STAFF REPORT: AUGUST 14, 2024, REGULAR MEETING
APPLICATION NUMBER: HDC2024-00364

ADDRESS: 134 ARDEN PARK

SCOPE: INSTALL CONCRETE PAVEMENT IN FRONT YARD

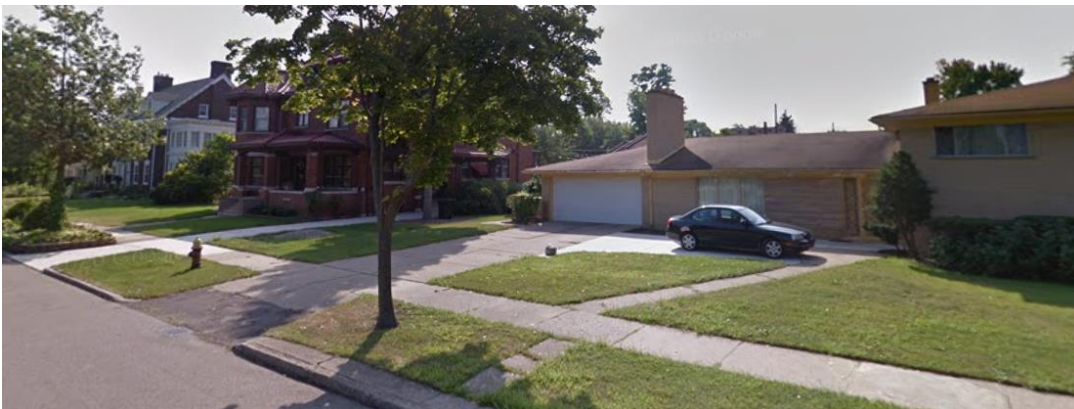
- In early-twentieth-century Detroit neighborhoods in general, a driveway (if it exists at all) is limited to relatively narrow path leading to a parking and loading area that is behind the house—it is not, itself, a parking or loading area. Houses from the historic period typically also have relatively narrow pedestrian pathways leading from the street to a front or side entrance. The paving of additional front-yard area beyond the minimal driveway and pedestrian walkway areas is a relatively recent, suburban-style development pattern, not appropriate in the context of Detroit’s historic neighborhoods.

- A visual survey of the Arden Park-East Boston Historic District indicates that the presence of broad, uninterrupted lawns, occasionally punctuated by rows of hedges or trees running perpendicular to the front facades of individual houses, is a defining aspect of the visual character of the district.

- Further, the Elements of Design (quoted above) specifically note the characteristic nature of open space, grass lawns, and, specifically, “straight, single-width driveways” in the district. In staff opinion, the interruption of these areas with additional paved surface would constitute “alteration of features and spaces that characterize a property,” contrary to Standard #2 (quoted in full below).

- The proposed work diminishes a character-defining open lawn space by adding an incompatible expanded paved surface.

Therefore, staff recommends that the Commission issue a Denial as the proposed work fails to meet the Secretary of the Interior’s Standards for Rehabilitation, in particular:
